WCAP-16308-NP-A
Revision 0

**Pressurized Water Reactor
Owners Group 10 CFR 50.69
Pilot Program –
Categorization Process –
Wolf Creek Generating Station**

SUBJECT: FINAL SAFETY EVALUATION FOR NUCLEAR ENERGY INSTITUTE (NEI) TOPICAL REPORT (TR) WCAP-16308-NP, REVISION 0, "PRESSURIZED WATER REACTOR OWNERS GROUP [(PWROG)] 10 CFR [TITLE 10 OF THE CODE OF FEDERAL REGULATIONS] 50.69 PILOT PROGRAM – CATEGORIZATION PROCESS – WOLF CREEK GENERATING STATION" (TAC NO. MD4229)

Figure I-1
Risk-Informed Safety Classification
Process

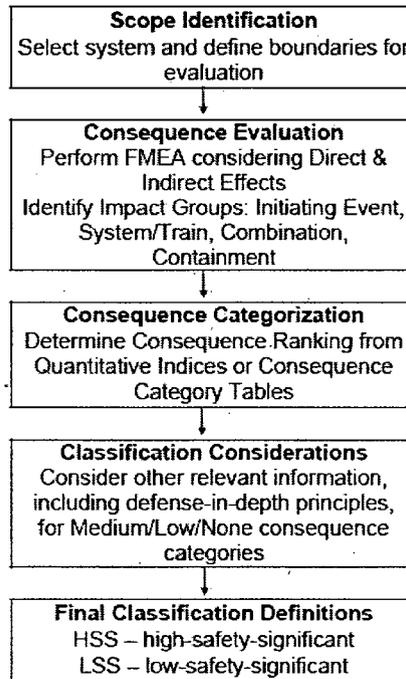
{ } [-9000]		No objection	Plant features – systems, structures, and components that can be used to prevent or mitigate an accident.
{I-1.0} [I-1.0]	Once categorized, the safety significance of piping of each piping segment is identified.	No objection	Once categorized, the safety significance of piping of each piping segment is identified. Figure I-1 illustrates the RISC methodology presented in the following sections. [Figure I-1]

Figure I-1: Risk-Informed Safety Classification Process

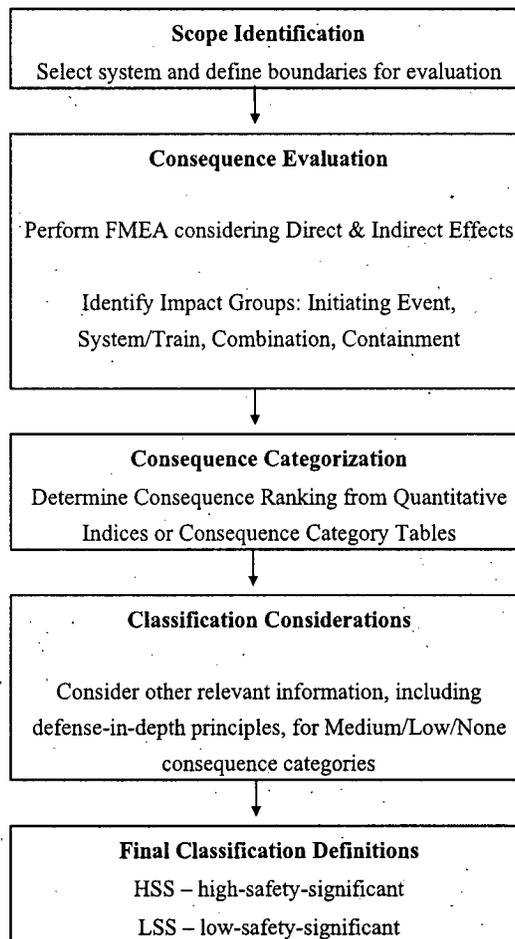
N-660, R0 Section	ASME Code Case N-660 Revision 0	Proposed Changes to ASME Code Case N-660 Revision 0 For PWROG Passive Categorization	Basis for Change
I-1.0	N/A	Added figure ¹ illustrating the modified RISC methodology process, including scope identification, consequence evaluation, consequence categorization, classification considerations, and final classification definitions.	Figure added to provide high level overview of RISC methodology process. New process calls for all segments to be included in the consequence evaluation to determine high, medium, low or none consequence category. Then only the non-high category segments would be considered in the classification considerations of I-3.2.2(b) – previously I-3.1.3.
	“Once categorized, the safety significance of each piping segment is identified”	Change to read, “Once categorized, the safety significance of each piping segment is identified Figure I-1 illustrates the RISC methodology presented in the following sections.	Text refers to the new figure.

Figure I-1
Risk-Informed Safety Classification Process

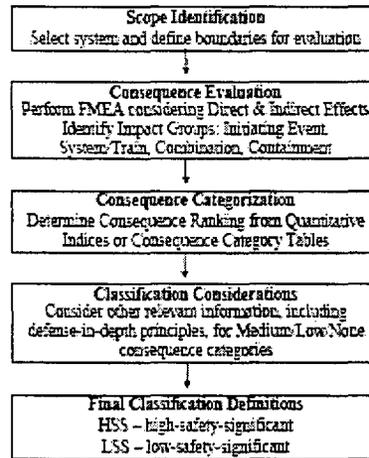
I-1.0	N/A	Added figure ¹ illustrating the modified RISC methodology process, including scope identification, consequence evaluation, consequence categorization, classification considerations, and final classification definitions.	Figure added to provide high level overview of RISC methodology process. New process calls for all segments to be included in the consequence evaluation to determine high, medium, low or none consequence category. Then only the non-high category segments would be considered in the classification considerations of I-3.2.2(b) - previously I-3.1.3.
